Our ref: AC001 – 6

**LAND EAST OF BEDFORD ROAD AND NORTH OF THE PRIORY SCHOOL,
HITCHIN (APPLICATION REFERENCE 25/03234/FP)**

Site Access
Swept Path Analysis
Refuse Vehicle

TITLE: Swept Path Analysis: NHDC Refuse

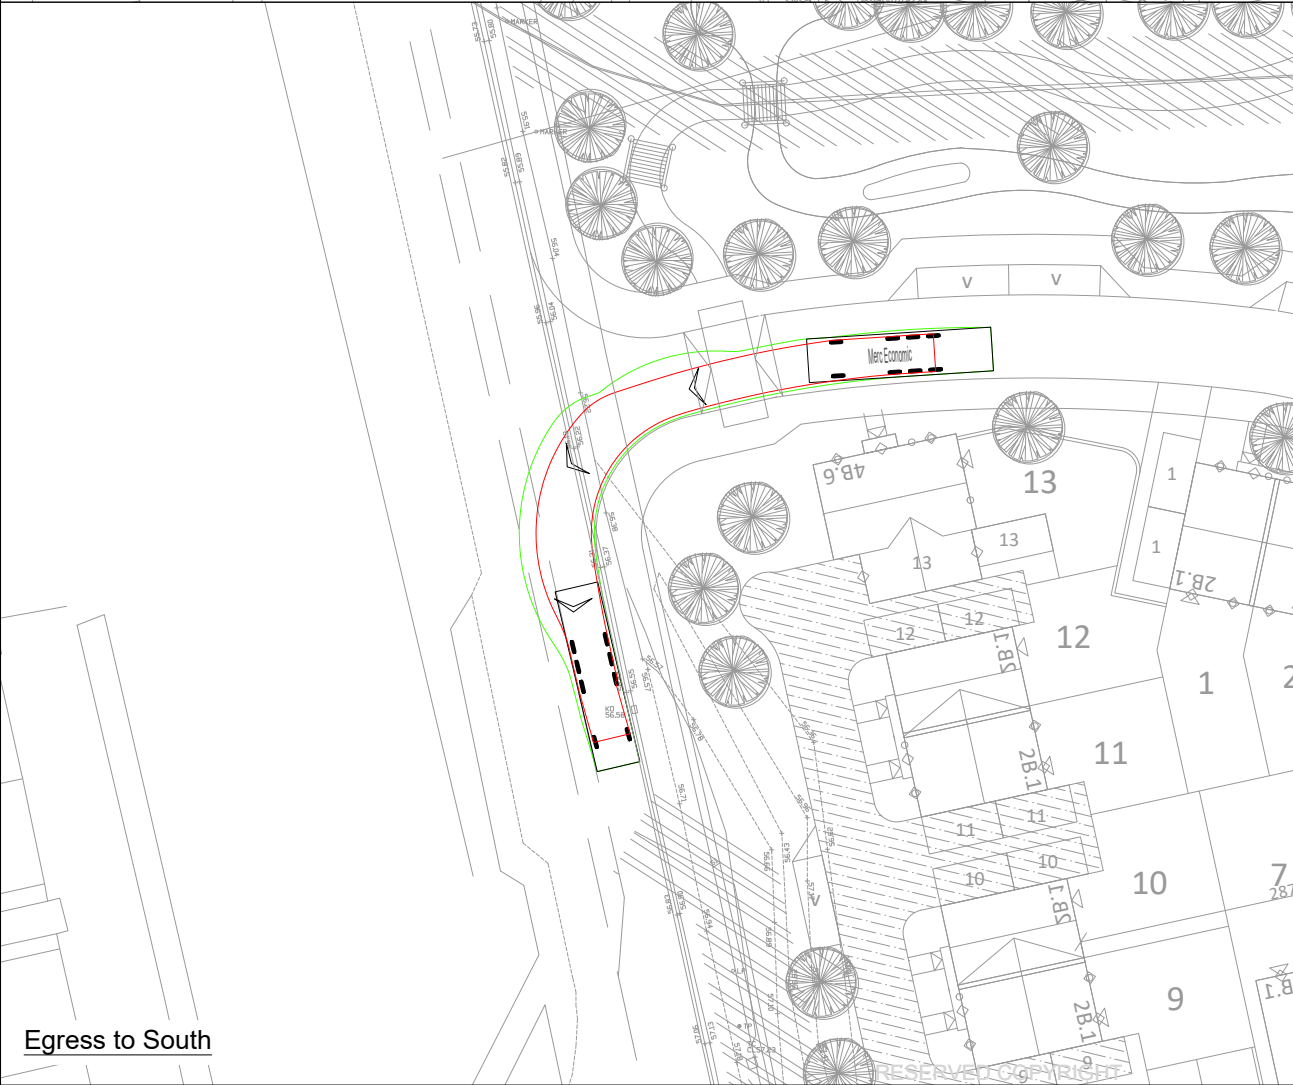
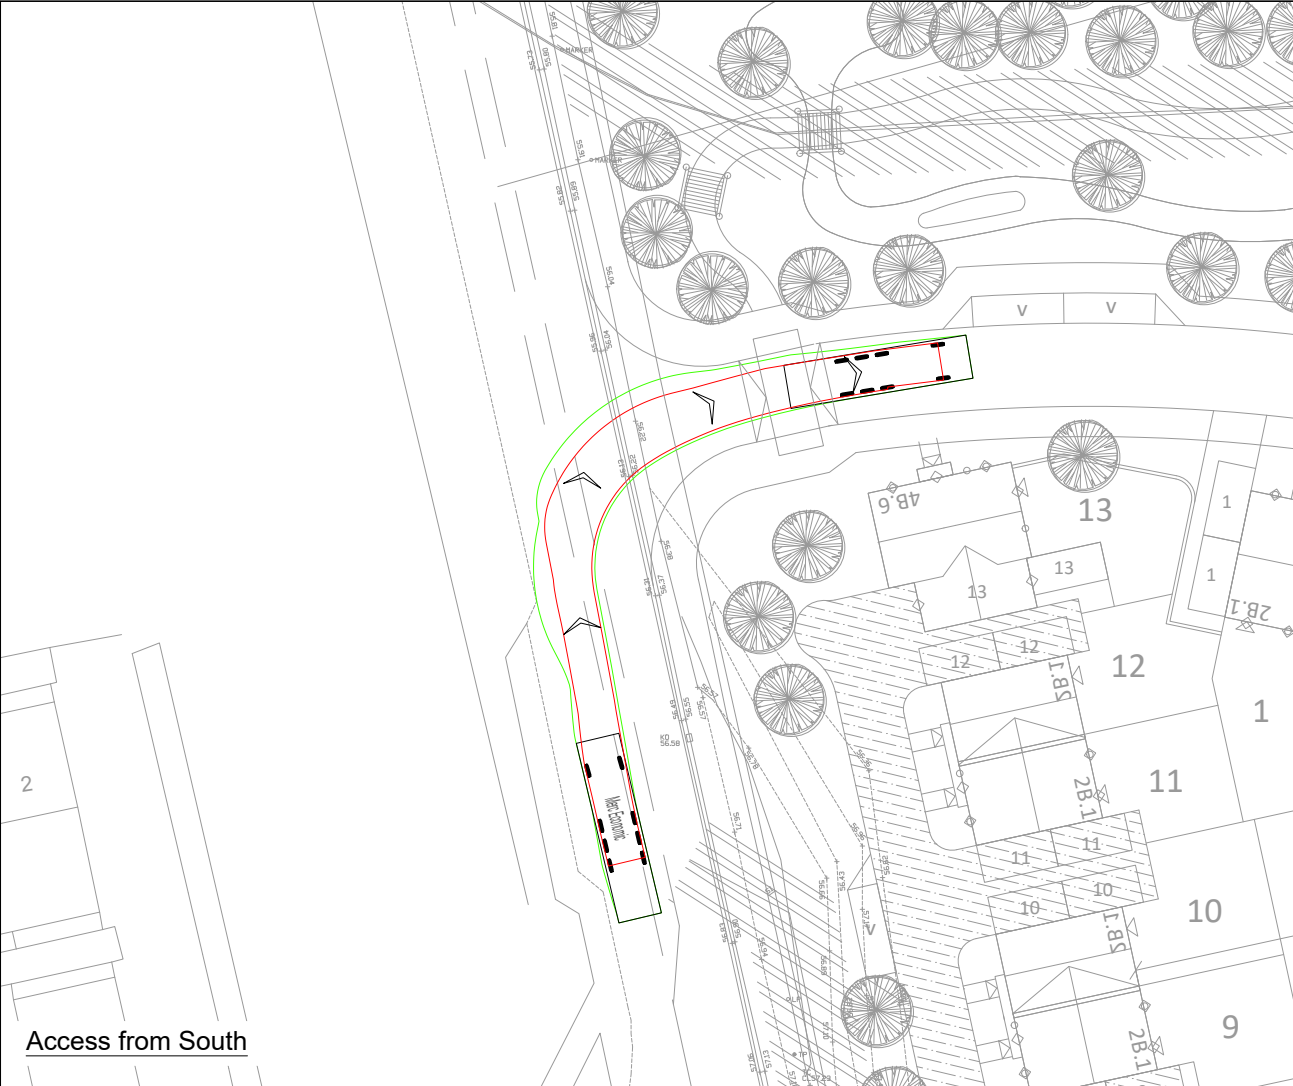
A comment was received from the council's Shared Waste Service, dated 26 June 2026, querying the ability for the refuse freighters to safely enter and exit the site and requesting a tracking diagram. A Swept Path Analysis diagram is already included in Appendix D to the Transport Statement (page 69 of the PDF copy), showing that a three-axle vehicle at 12.1 metres long can pass through the entrance without mounting the kerbs or overhanging the footway. The drawing is attached to this letter and, for the sake of clarity, the matching drawing from the 2022 application that shows the same manoeuvres for a four-axle vehicle at 12.2 metres long is also attached.

The proposed scheme will require access by at least two types of refuse freighters, with the domestic collection of black, purple, blue and brown lidded bins for the houses and the communal collection of mixed recycling, non-recyclables and cardboard/paper, therefore if the Shared Waste Service can confirm which vehicles will be used to service the scheme, the drawings can be updated further to confirm that there are no road safety issues at the entrance to the site.
